Access Compliance Report

Intersection ID: 26014	Main Street: ARRINGTON MANOR PL	Cross Street: HOLLY HILL FARM RD	Location: NW
ADA ID: 6380A40CA281	Ramp Type: BlendTrans2	Initial Pass/Fail: Fail	Overall Compliance: No
Severity Score: 25			
Codes/Mitigation Info/Possible Solution		Field Measurements/Component Compliance

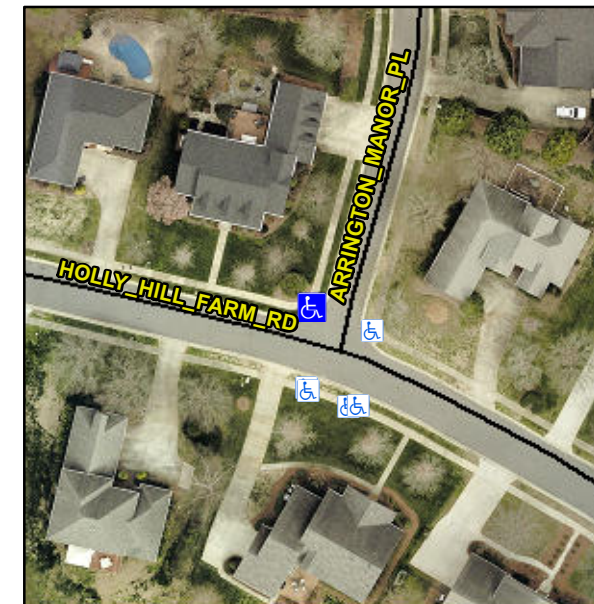
Remove & Replace Curb Ramp With Two New Directional Ramps or Equivalent.

R304.5.3

Compliance	Description	Data	Compliance	Description	Data
N/A	Ramp Length (in)	97.0	Yes	BlendTrans Slope (%)	2.5
Yes	Ramp Width (in)	76.0	No	BlendTrans XSlope (%)	11.2
N/A	Flare Type LT	N/A	N/A	Flare Type RT	N/A
N/A	Flare Slope LT (%)	N/A	N/A	Flare Slope RT (%)	N/A
N/A	Flare Traversable LT?	N/A	N/A	Flare Traversable RT?	N/A
N/A	Landing Length (in)	N/A	N/A	DWS Provided?	N/A
N/A	Landing Width (in)	N/A	N/A	DWS Contrast?	N/A
N/A	Landing Slope (%)	N/A	N/A	DWS Length (in)	N/A
N/A	Landing X Slope (%)	N/A	N/A	DWS Full Width?	N/A
N/A	Landing Curb? (Y/N)	N/A	N/A	DWS Offset (in)	N/A
N/A	Shared Landing?	N/A			
N/A	Gutter Ponding?	N/A	N/A	Gutter Slope (%)	N/A
N/A	Gutter Lip Ht (in)	N/A	N/A	Gutter X Slope (%)	N/A
N/A	Painted X Walk1?	No	N/A	Painted X Walk2?	No
	X Walk 1 Direction	To S		X Walk 2 Direction	To SE
	X Walk 1 Width (in)	N/A		X Walk 2 Width (in)	N/A
	X Walk 1 Slope (%)	2.1		X Walk 2 Slope (%)	6.9
	X Walk 1 X Slope (%)	7.1		X Walk 2 X Slope (%)	2.1
